Re: 17 North Lake Road
Site Plan Response Memo

This Memorandum responds to the outstanding Site Plan comments set forth in the Kellard Sessions Consulting, P.C. Memorandum, dated November 5, 2020. Kellard's comments are provided below, with our responses in italics.

SITE AND DEMOLITION PLAN
DIMATTEO RESIDENCE

DRAINAGE & EROSION CONTROL PLAN

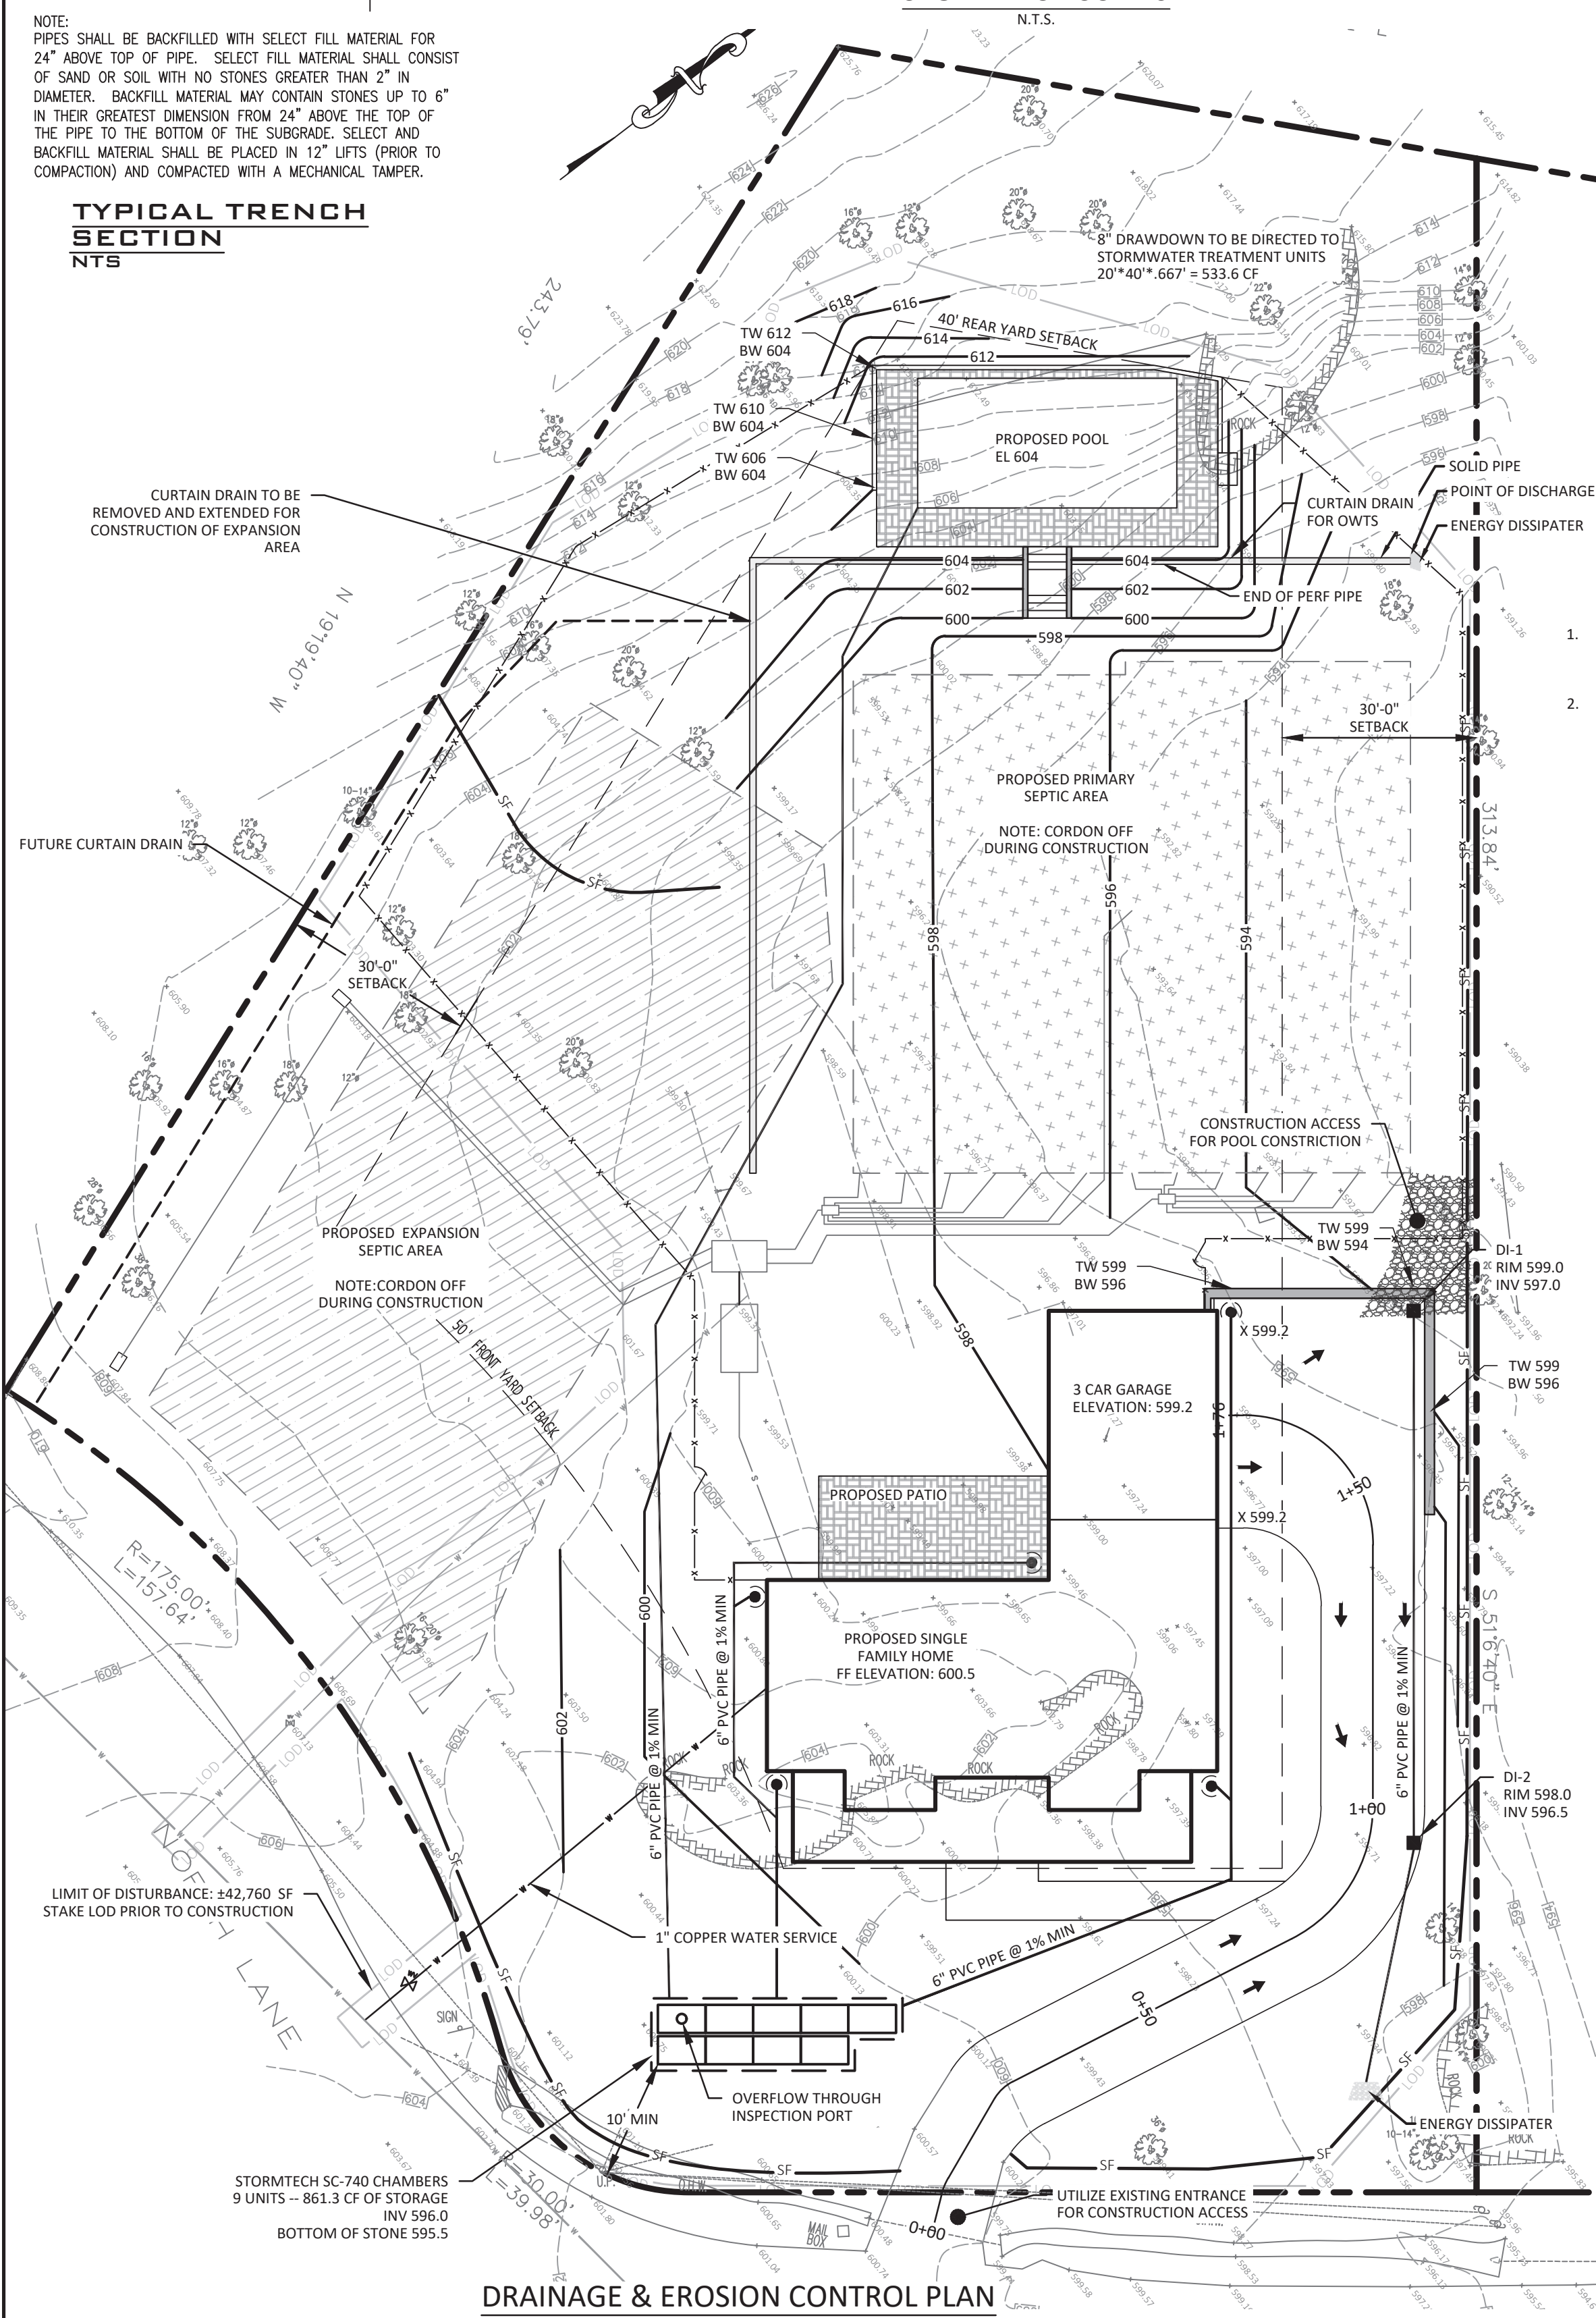
5. It is the policy of the Town that, for a teardown and rebuild of a house, the applicant shall demonstrate that adequate stormwater mitigation is provided through the 100-year storm event for the runoff generated by the net increase in impervious surface. The design calculations and system layout shall be updated accordingly. The calculations shall also be updated as necessary to account for the soil test results to be performed.

13. The erosion and sediment control plan shall illustrate construction access for the pool. The plan shall illustrate the primary and reserve septic areas to be cordoned-off during construction to restrict equipment staging and material stockpiling.

14. The proposed limit of disturbance shall be illustrated on the erosion and sediment control plan for coordination with proposed improvements, pool fence installation and associated grading. The limits shall be adjusted as needed and include any off-site improvements. The plan shall note that the limit will be staked in the field prior to construction.

Revised calculations are shown on sheet 2 which demonstrate mitigation for the 100-year storm.

Access for pool construction is proposed on the right side of the primary septic area and can be seen on sheet 2 of the plans.

The limit of disturbance is shown and called out on sheet 2 of the plans.

STONE RETAINING WALL 8 FEET MAX HEIGHT
N.T.S.

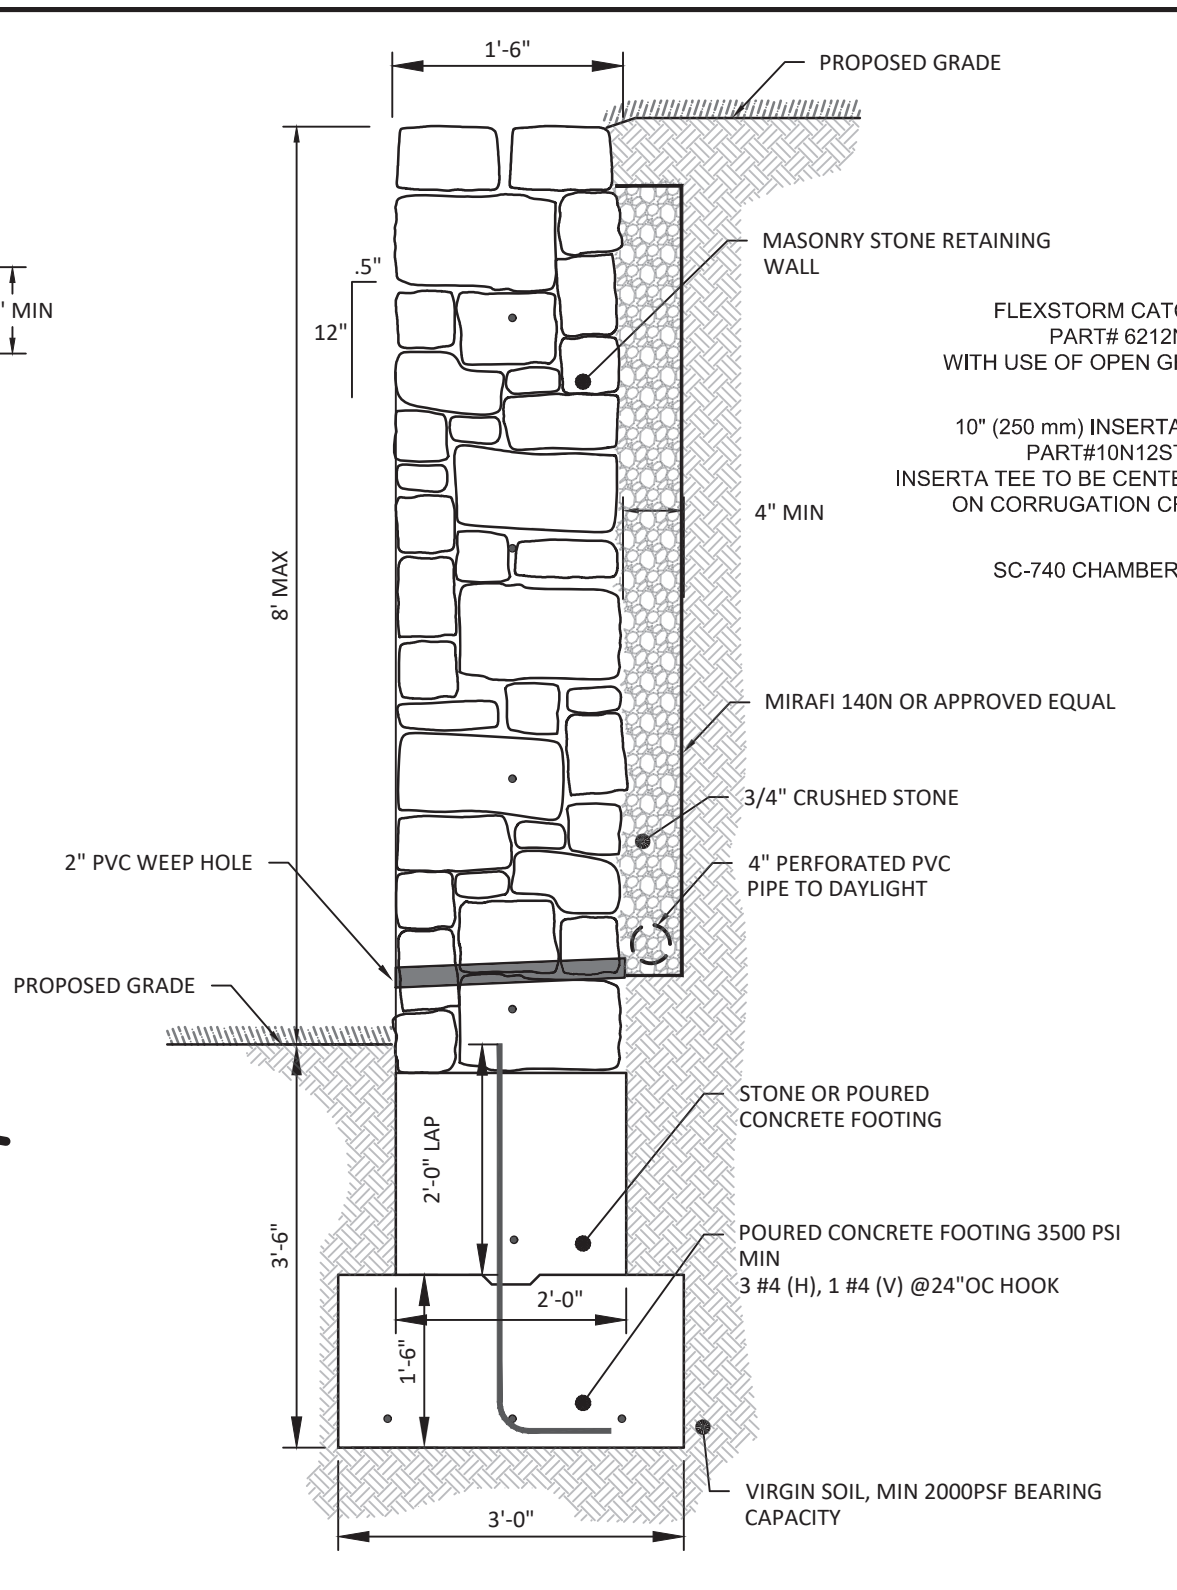
2. The plan proposes an eight (8) foot high retaining wall required for the construction of the pool. The retaining wall design and detail shall be revised to reflect the maximum required height. In addition, the plan shall note that (1) all walls equal to or greater than four feet in height shall be designed by a New York State Licensed Professional Engineer and all design and construction details provided, prior to the issuance of a Building Permit; and (2) the owner shall provide certification by the Design Engineer that the construction of all walls equal to or greater than four (4) feet in height, have been constructed in accordance with the approved plans, prior to the issuance of a Certificate of Occupancy.

The retaining wall detail has been revised to reflect the correct height. Appropriate notes regarding certification and design have been added to sheet 2 under the retaining wall detail.

- RETAINING WALL NOTES**
- WALLS EQUAL TO OR GREATER THAN FOUR FEET IN HEIGHT SHALL BE DESIGNED BY A NEW YORK STATE LICENSED PROFESSIONAL ENGINEER AND ALL DESIGN AND CONSTRUCTION DETAILS PROVIDED, PRIOR TO THE ISSUANCE OF A BUILDING PERMIT.
 - CERTIFICATION BY THE DESIGN ENGINEER THAT THE CONSTRUCTION OF ALL WALLS EQUAL TO OR GREATER THAN FOUR (4) FEET IN HEIGHT, HAVE BEEN CONSTRUCTED IN ACCORDANCE WITH THE APPROVED PLANS, SHALL BE PROVIDED PRIOR TO THE ISSUANCE OF A CERTIFICATE OF OCCUPANCY.

SC-740 INSPECTION PORT
N.T.S.

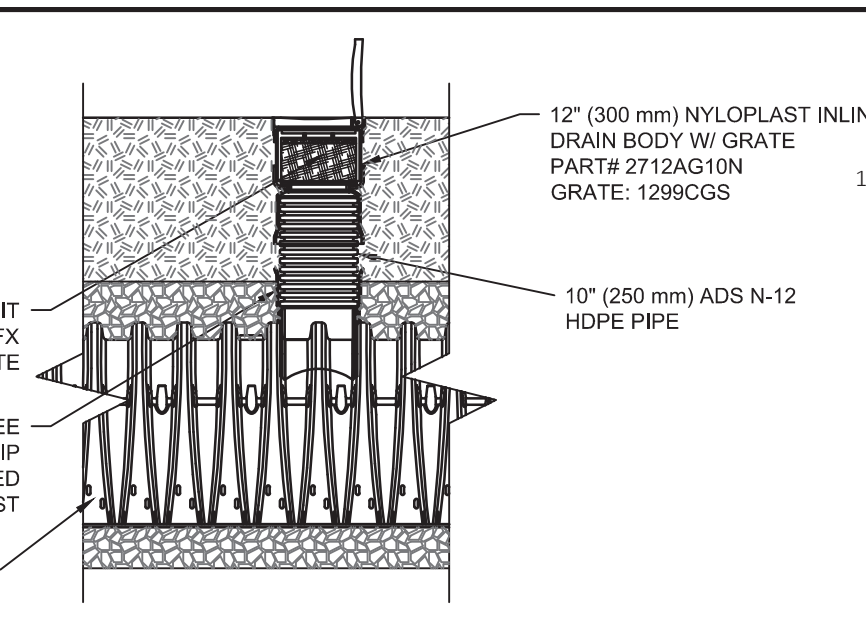
12. The infiltration system shall have an emergency overflow system. Provide any necessary details.

The infiltration is proposed to overflow through an inspection port. An inspection port detail has been provided on sheet 2 of the plans.

PAVEMENT REPLACEMENT OVER TRENCH DETAIL
 N.T.S.

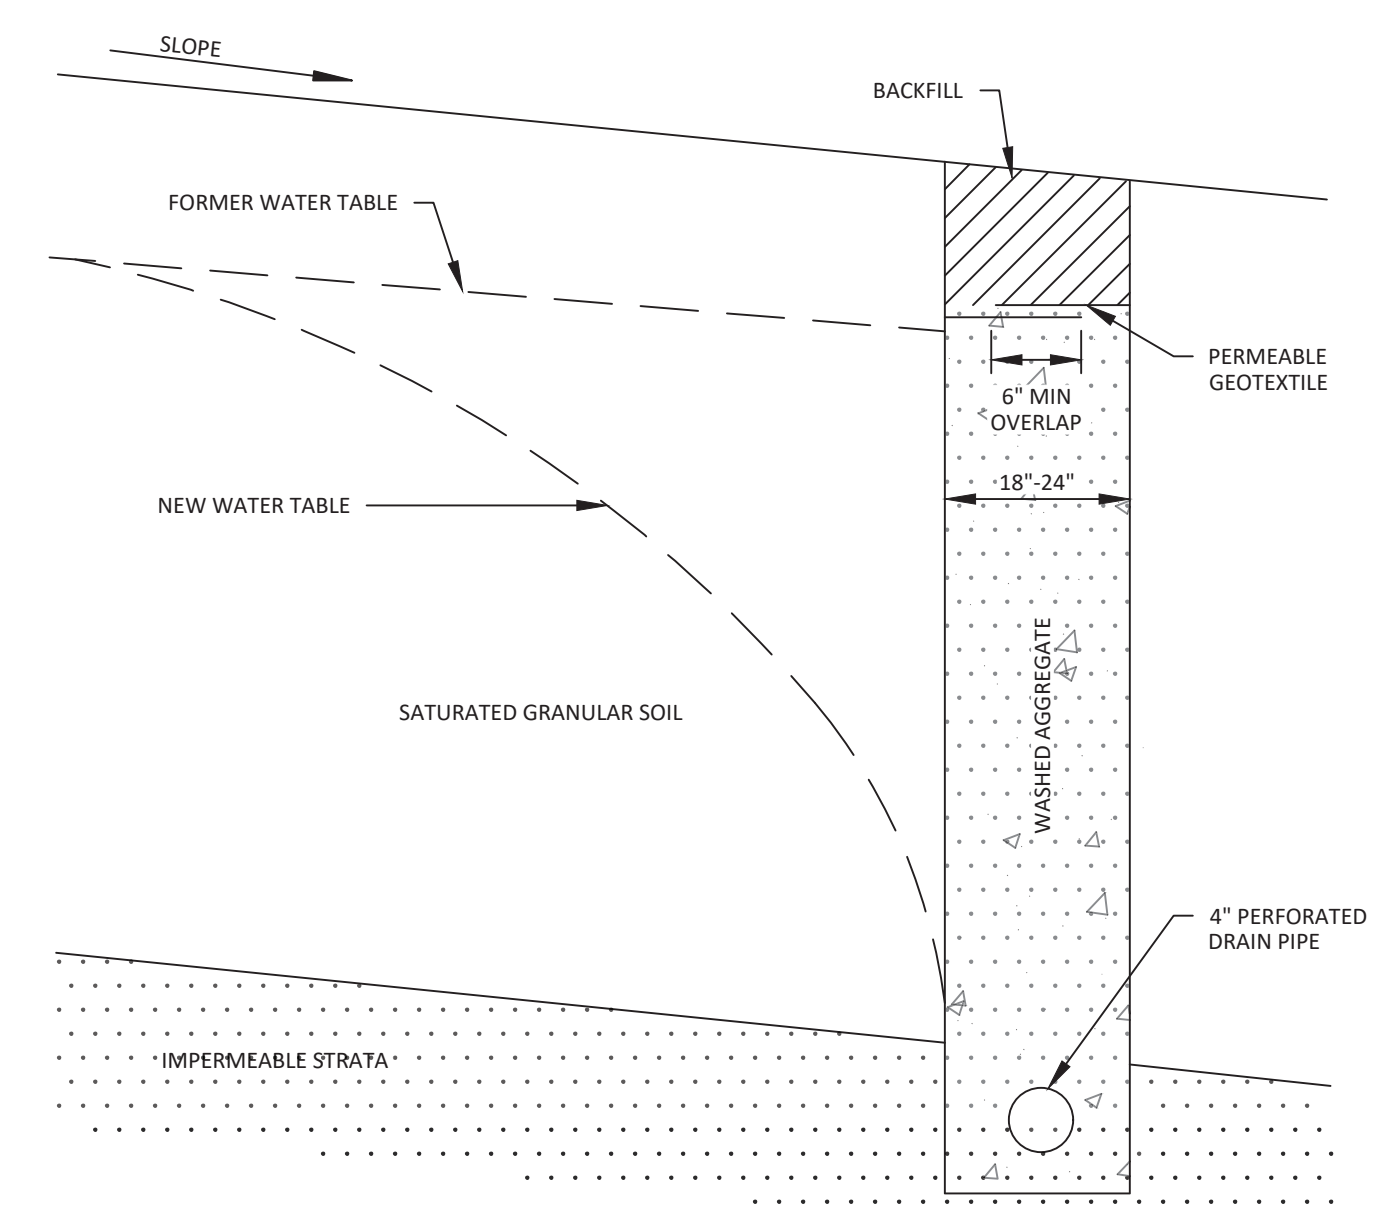
9. The plan shall include road restoration details required for the water service connection, in accordance with Town Highway Department standards.

A pavement replacement detail has been provided on sheet 3 of the plans.

NOTE:
 ALL DRAINAGE PIPE SHALL HAVE A MINIMUM OF TWO (2) FEET OF COVER IN TRAFFIC AREAS AND ONE (1) FOOT OF COVER IN NON-TRAFFIC AREAS

CURTAIN DRAIN DETAIL
 N.T.S.

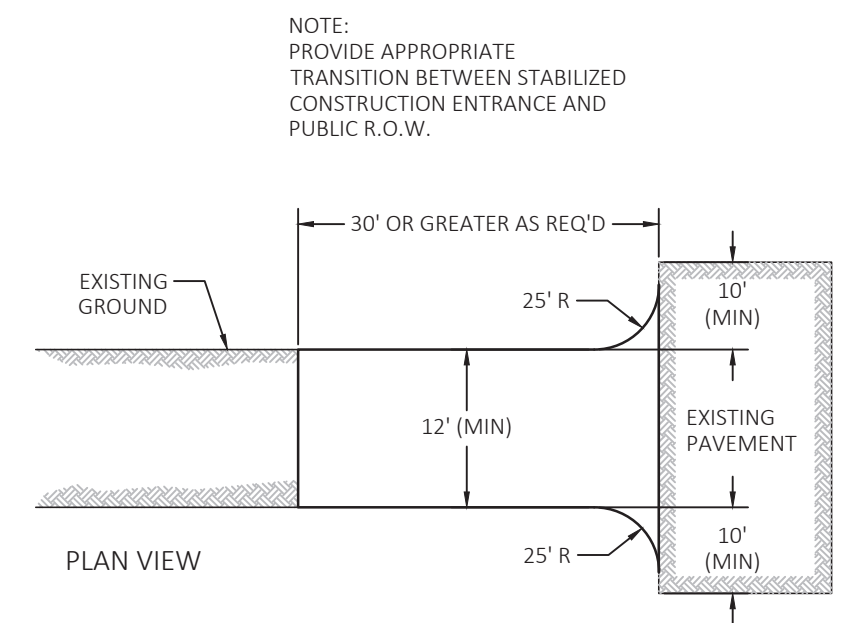
11. The stormwater collection system for the pool patio shall be shown and detailed on the site plan.

The pool patio runoff is proposed to be captured by the curtain drain. Curtain drain detail has been provided on sheet 3.
